10 East Road, N1

proposed south block
east elevation

job no. 0761 drawing PA182 rev. A

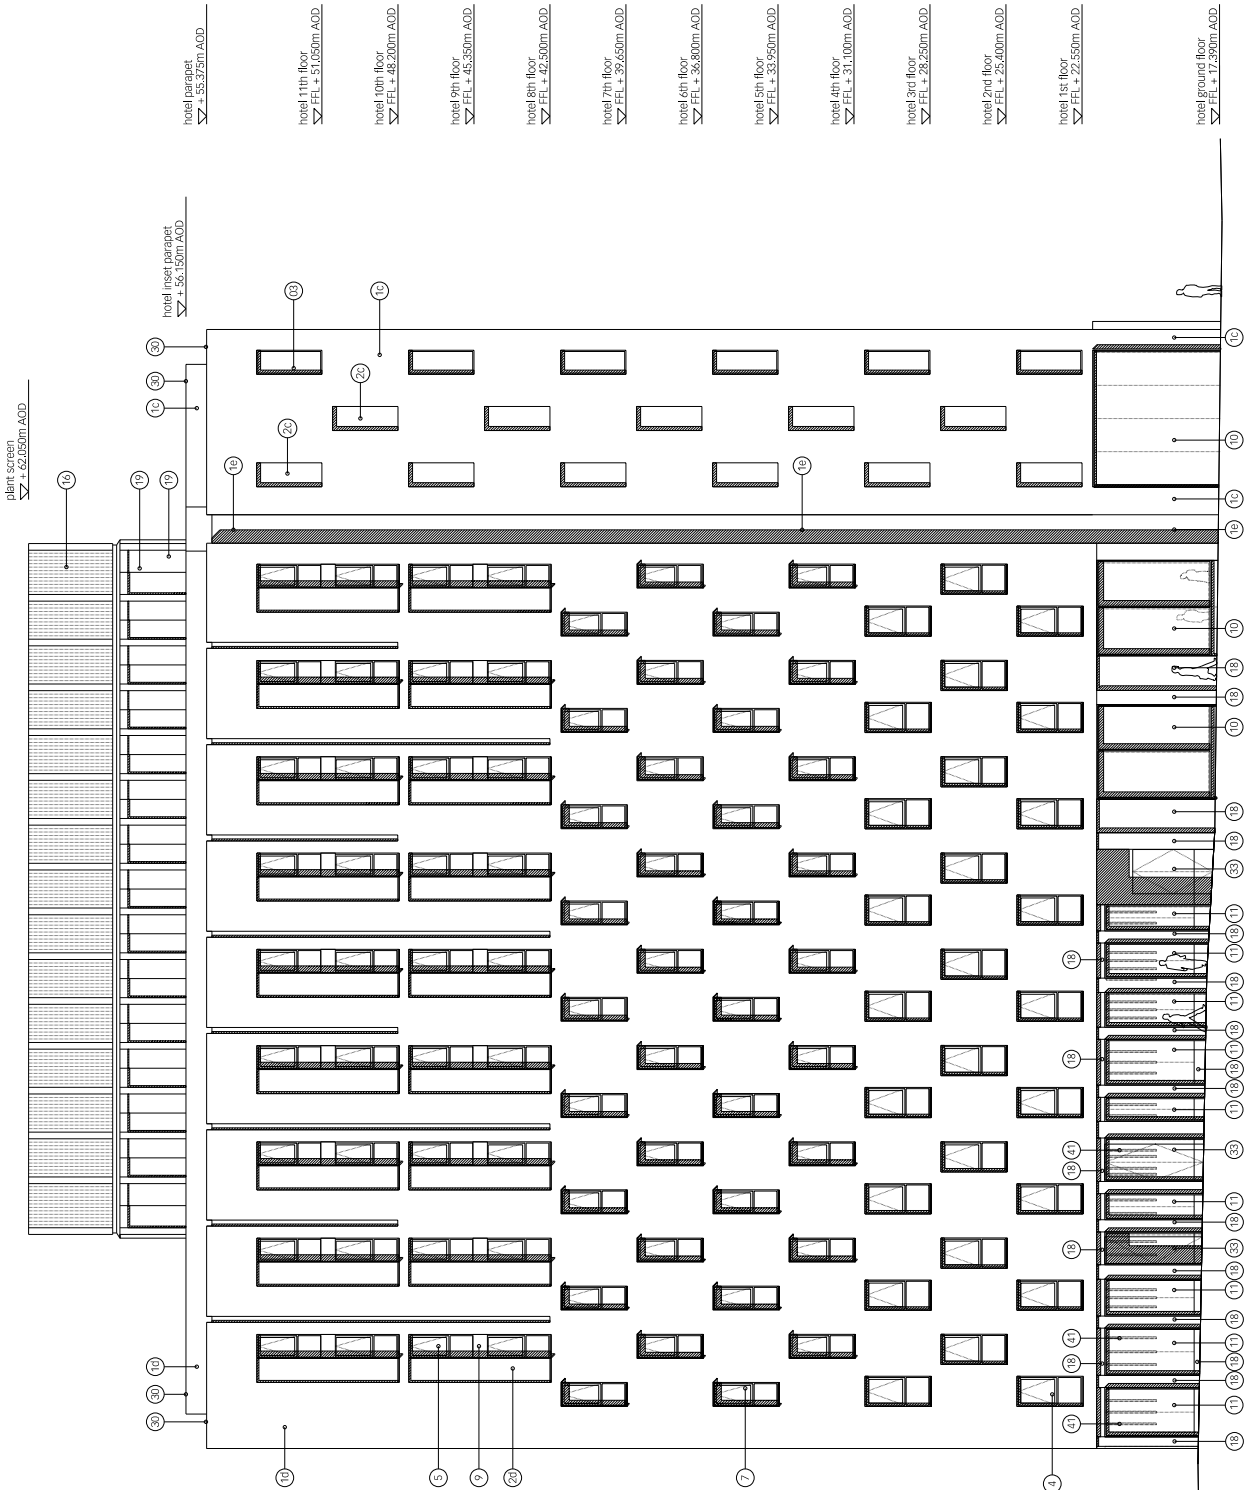
Advise to hotel consider omitted.
hotel window recessed, height
elevation at ground floor revised.
layout of plant screen revised.
legend and annotations amended.
